**SUBJECT: RECALL R09PB BATTERY POWER CABLE ROUTING**

# Battery Cable Routing **RECALL**

**MODELS AFFECTED:** 2007-2008 BBCV with Caterpillar C7 Engines

L-shaped bracket

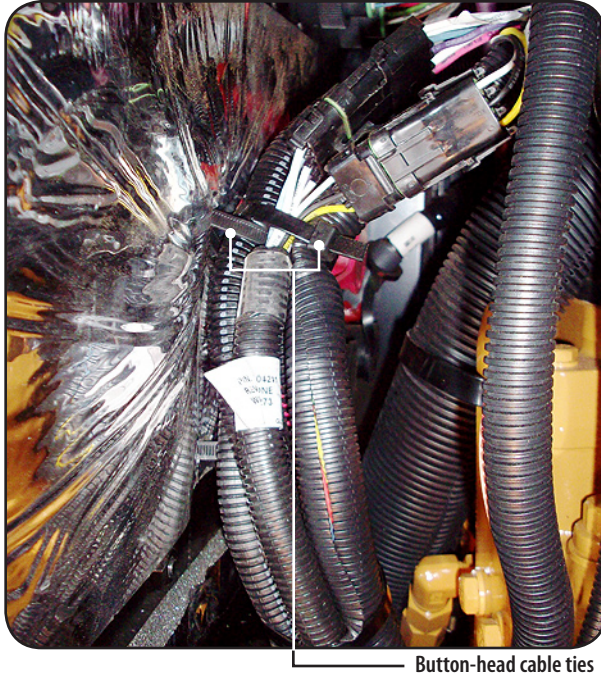
A saddle block is bolted to this bracket, and supports a battery cable, attached by a cable tie. Inspect the battery cable for contact with the saddle block's mounting bolt or with any portion of the engine, as follows:

- If any chaffing or other damage is evident, perform **Sub Procedure A: Cable Protector Installation**.

- If no chaffing or other damage is evident, but clearance between the cable(s) and any part of the engine is less than ½", reposition and secure the cable to obtain ½" clearance. If the cable cannot be repositioned, perform **Sub Procedure A: Cable Protector Installation**.

- If the L-shaped bracket, saddle block, nut, washer and cable tie are present and there is no evidence of contact or damage to the battery cable, and the required ½" clearance is provided, proceed to Step 7.

Area of possible cable damage against front edge of transmission cover plate

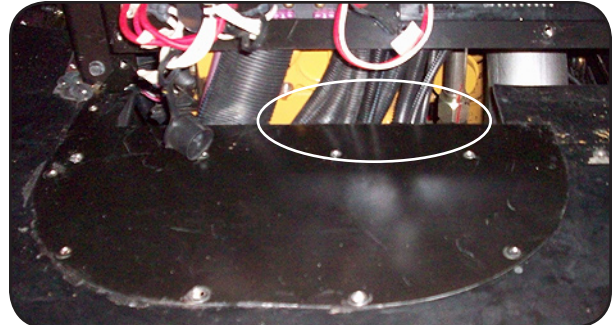
7.4 Inspect all the harnesses passing under the front edge of the transmission cover, as follows:

- If no contact between the transmission cover and harnesses is evident, proceed to step 8.
- If any evidence is found of chaffing or other damage due to contact against the transmission cover, perform **Sub Procedure B: Relocate Transmission Cover**.

**1** If any contact between battery cables and the transmission cover is evident after the inspection described in step 7.4, relocate the Transmission cover as follows:

- 8.1 Remove the fasteners for the transmission cover plate.
- 8.2 Slide the transmission cover plate rearward approximately ½".
- 8.3 Install the lower cover panel between the Power Distribution Unit and the transmission plate with the existing fasteners.
- 8.4 Slide the transmission cover plate rearward until the rear of the transmission cover plate is 10" from the vertical surface of the lower panel.

- 8.5 Using a .218" drill bit with a drill stop set at 1 ¼", using the transmission plate as a guide, drill new attaching holes for the transmission cover plate. Reinstall the transmission cover plate in the new location, using the original fasteners.

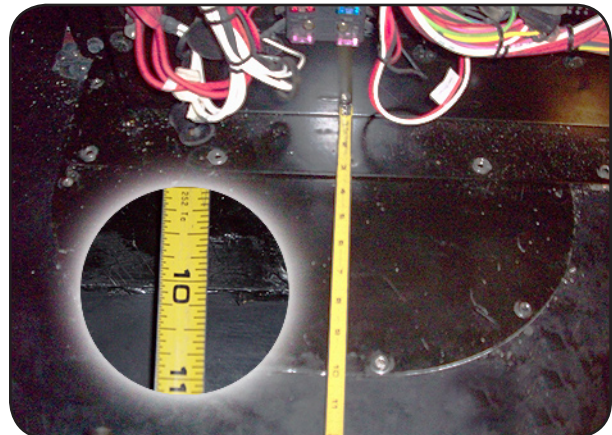
- If the loom has been rubbed, but no damage to the battery cable inside has occurred, then install cable protector (BB # 0040818) between the engine and battery cable. Wrap the protector around the cable loom and secure it with two Cable Ties (BB # 0029999) as shown below.
